VALUE ENGINEERING STUDY

Project # IM000-0285-01(346) PI No. 713210-

I-75 NB C-D System from Forest Parkway to I-285
Clayton County, Georgia

25 August 2011

PROPOSAL NUMBER: B-1.0

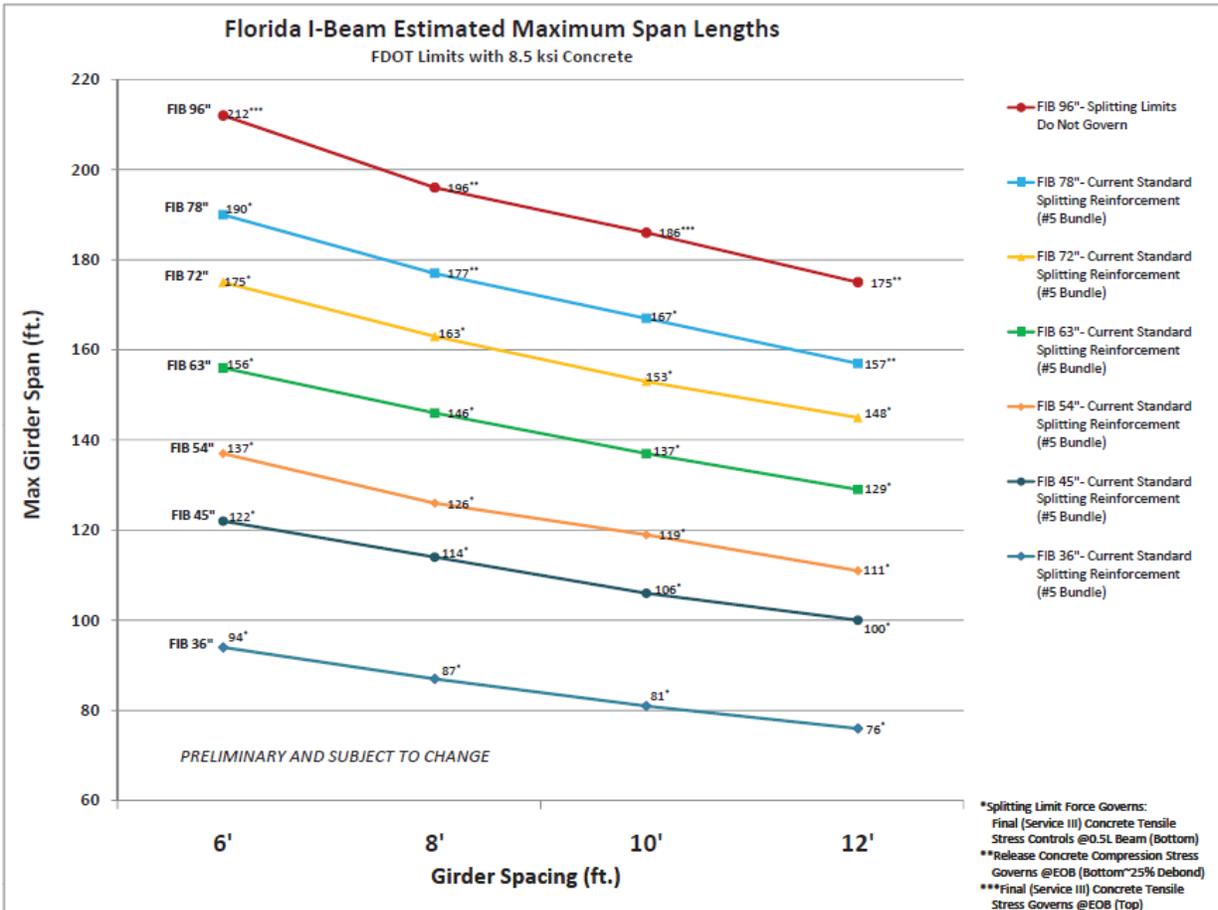
PROPOSED CHANGE: It is proposed to use fifty-two (52) 36" Florida I Beams @ 9' - 10" spacing with 4'-3" overhangs. (Span Length = 79 ft on skew; beam spacing = 13'-4 13/16" along Ramp A, with 5'-8 13/16" overhangs).

PROPOSAL NUMBER: B-4.0

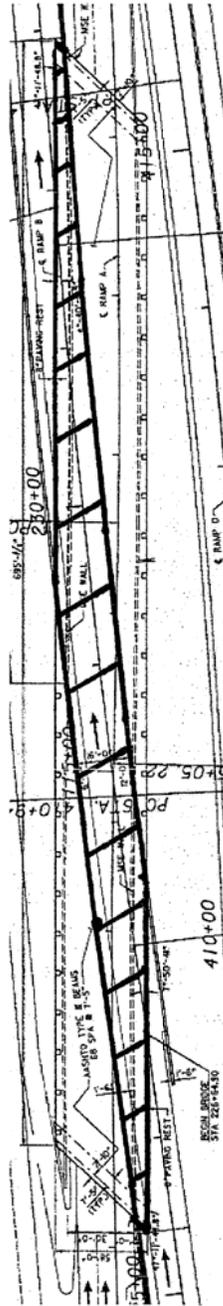
ORIGINAL DESIGN: The current design includes a 790' x 45' Concrete Bridge Braided Ramp (Actual dimensions are 695' x 58' - per Bridge sheet 1 of 1). The cost estimate includes the new bridge @ \$100/SF, and includes the cost of deck over entire bridge area (40,310 SF).

PROPOSED CHANGE: It is proposed to construct the Concrete Bridge elements for the 695' x 58' Braided Ramp; however, placing the deck only below where it is needed for the vehicle travelway (18,478 SF).

PROPOSAL NUMBER: B-6.0

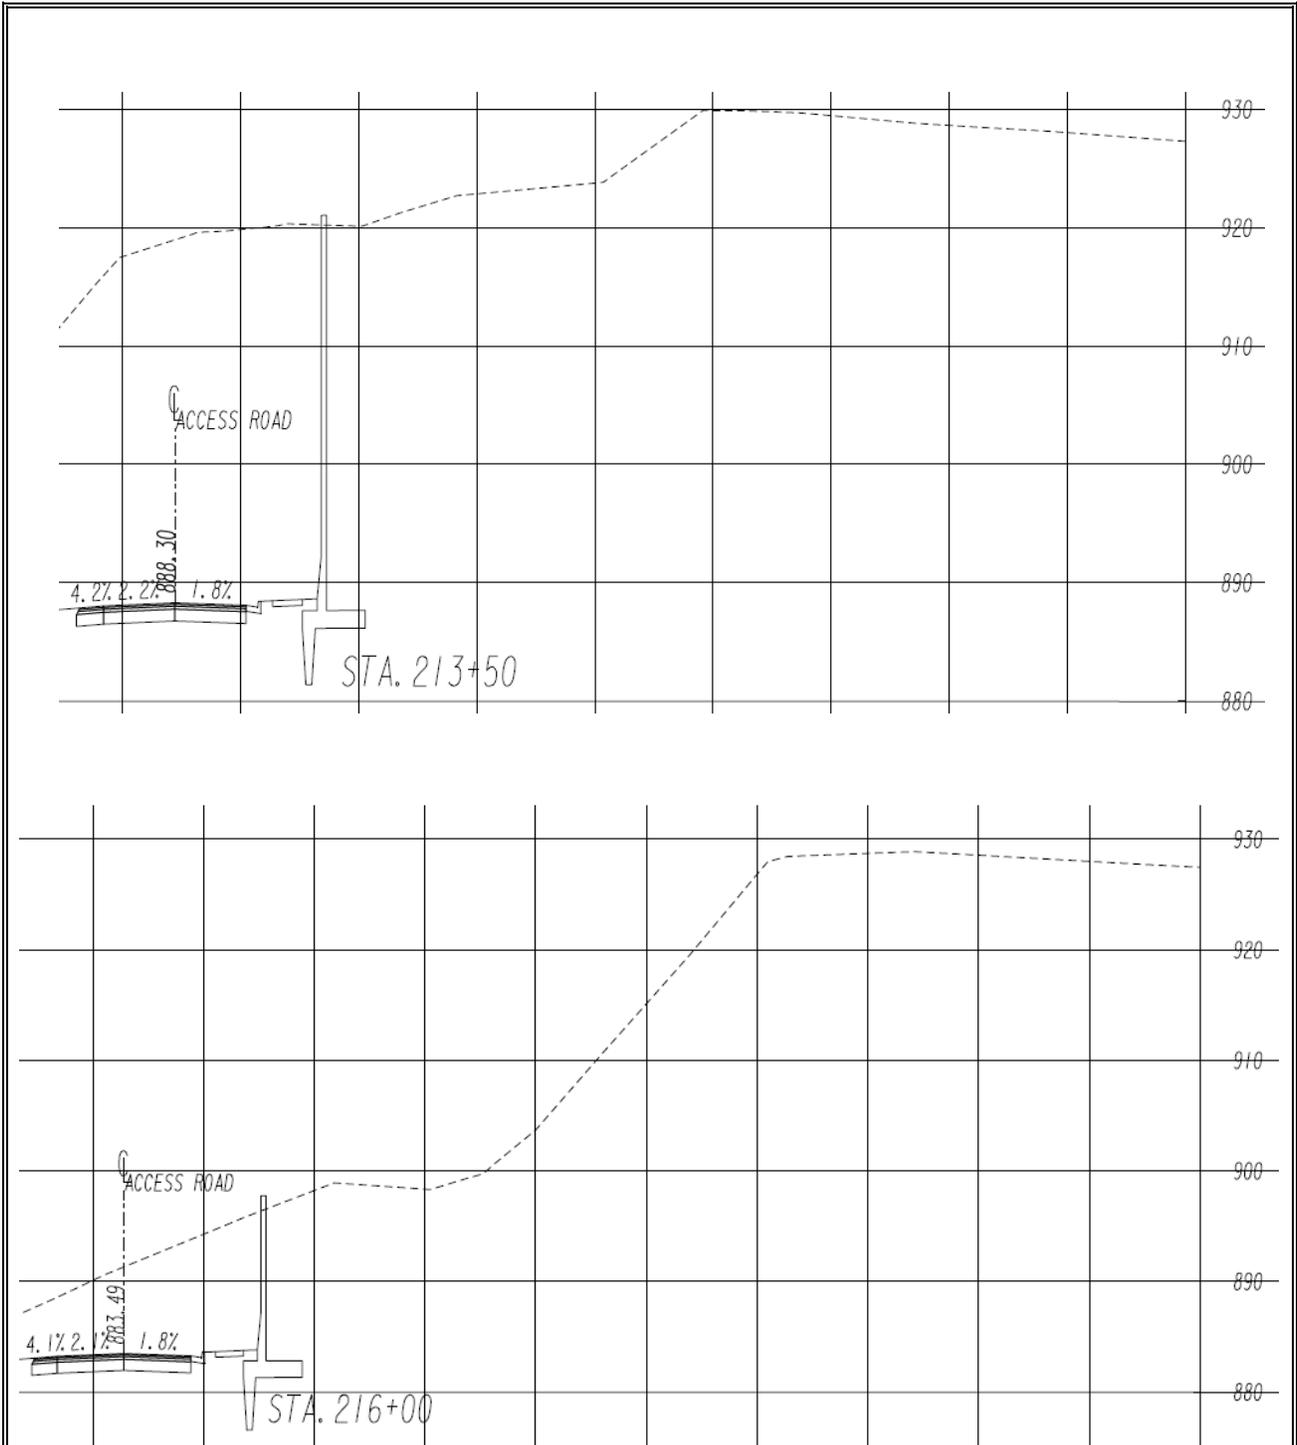
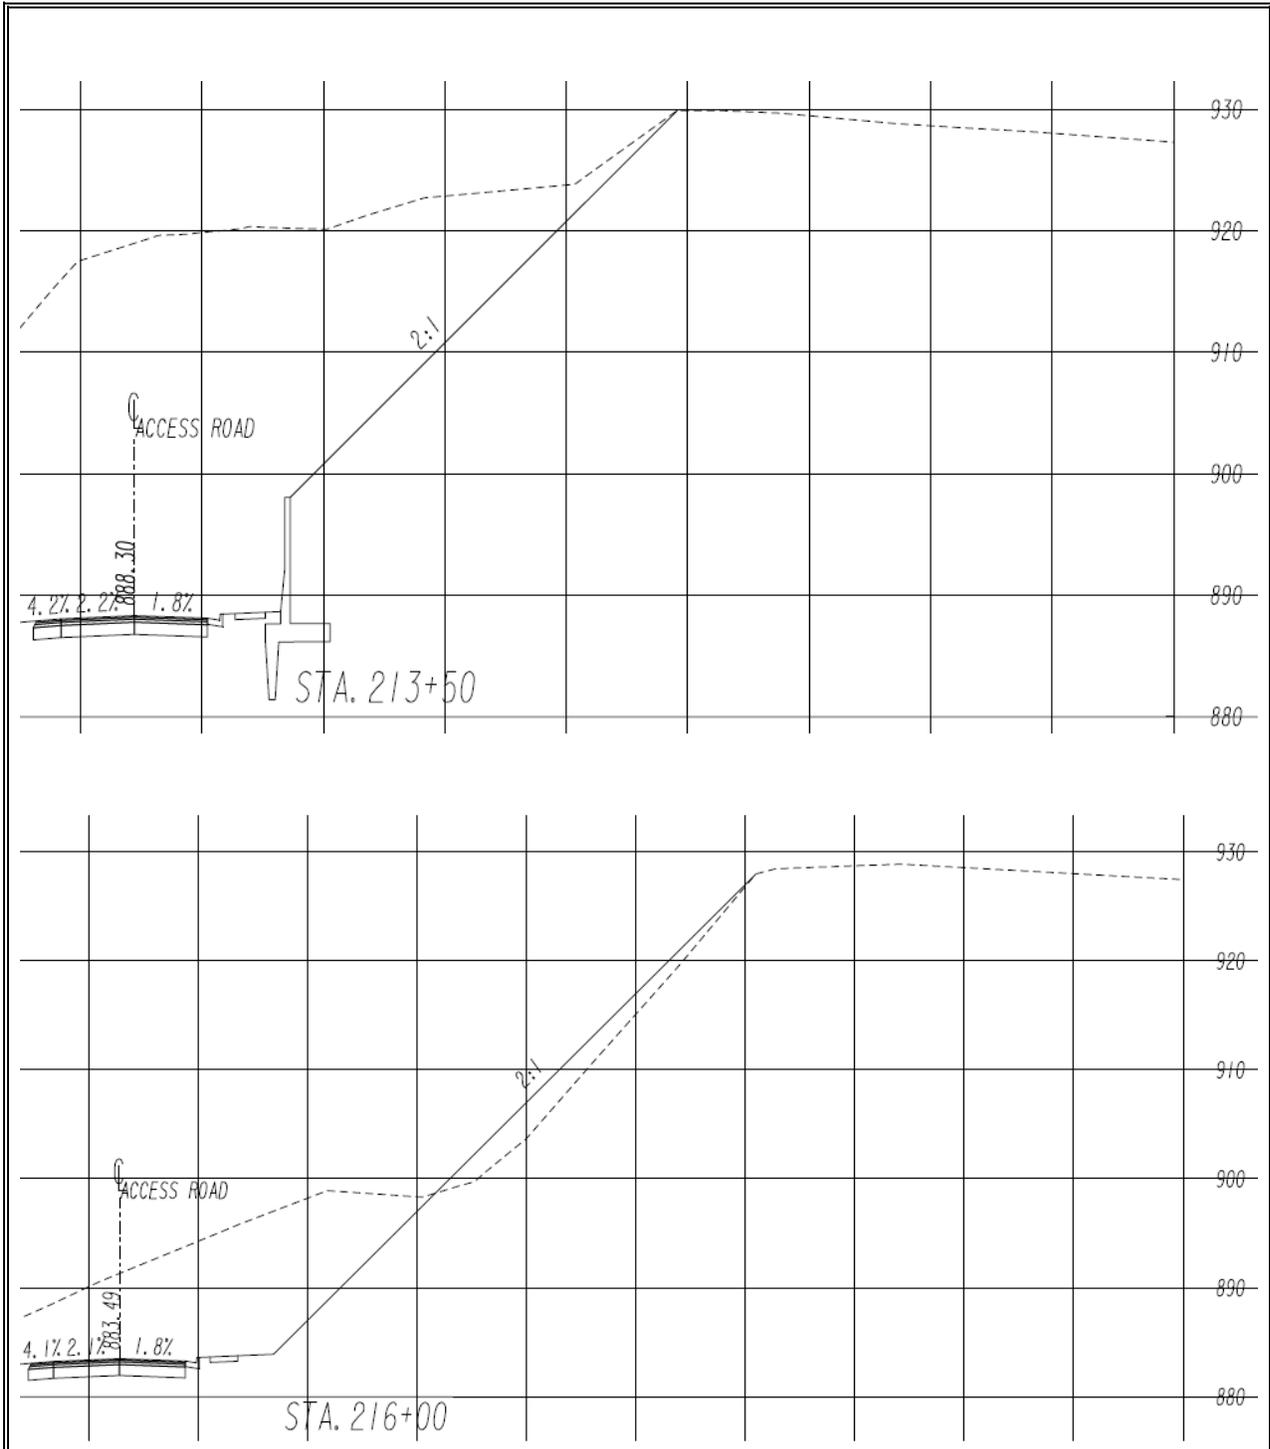
PROPOSED CHANGE: It is proposed to lower or remove the retaining wall between Frontage Road and the Farmers Market from STA 213+00 to STA 216+00.

PROPOSAL NUMBER: B-6.1

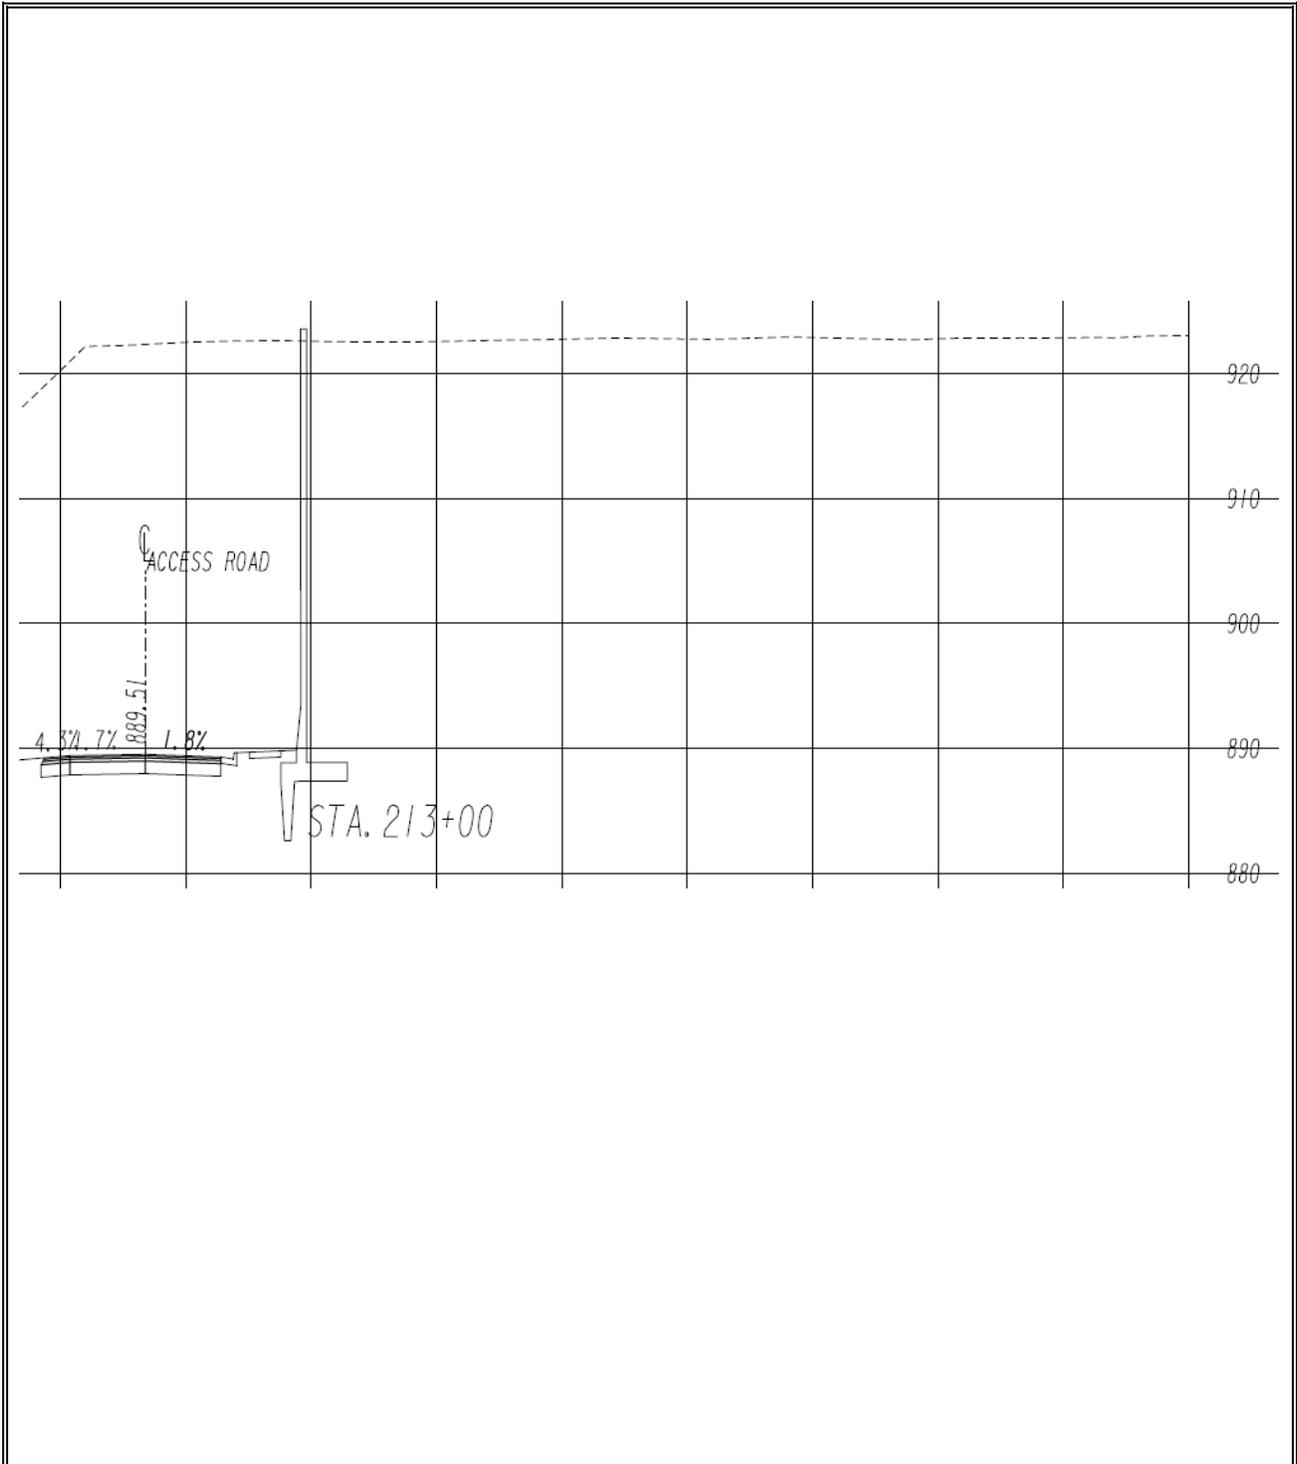
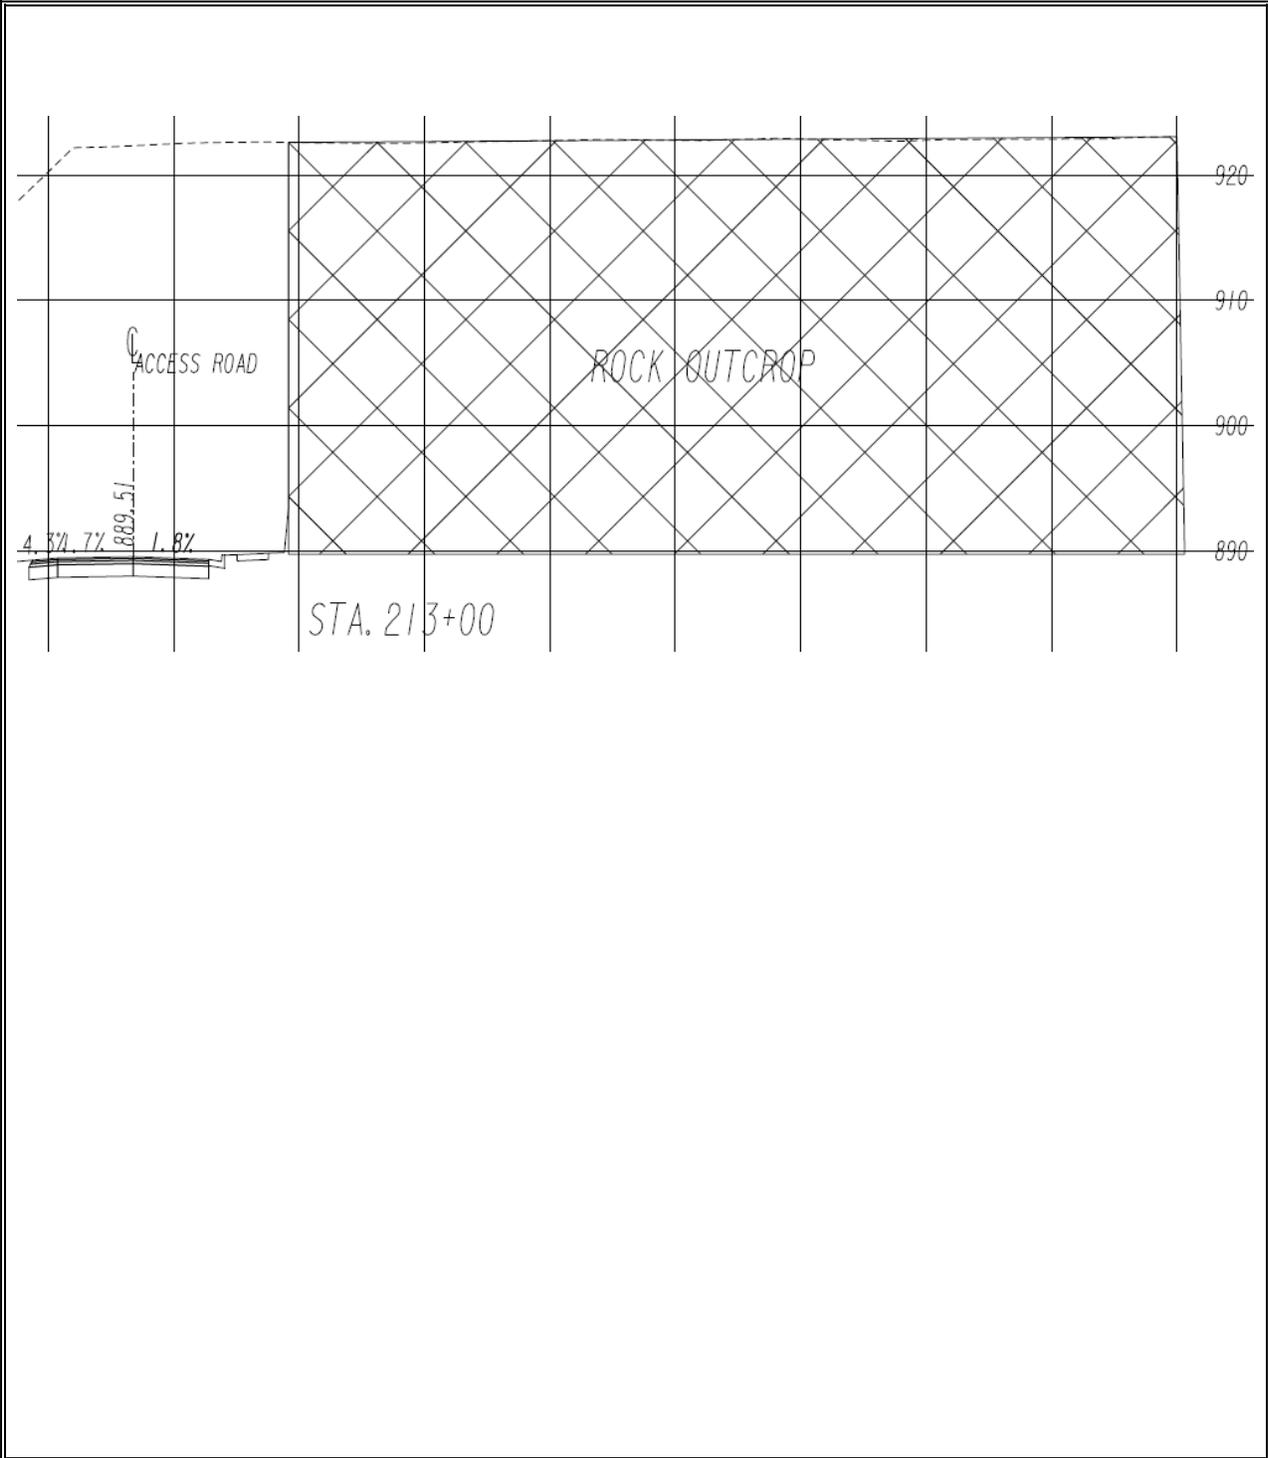
PROPOSED CHANGE: For several hundred feet along the Frontage road there are visible rock outcroppings. It is proposed to eliminate construction of the retaining wall between Station 208+00 and 213+00 (500 ft.) due to rock outcropping.
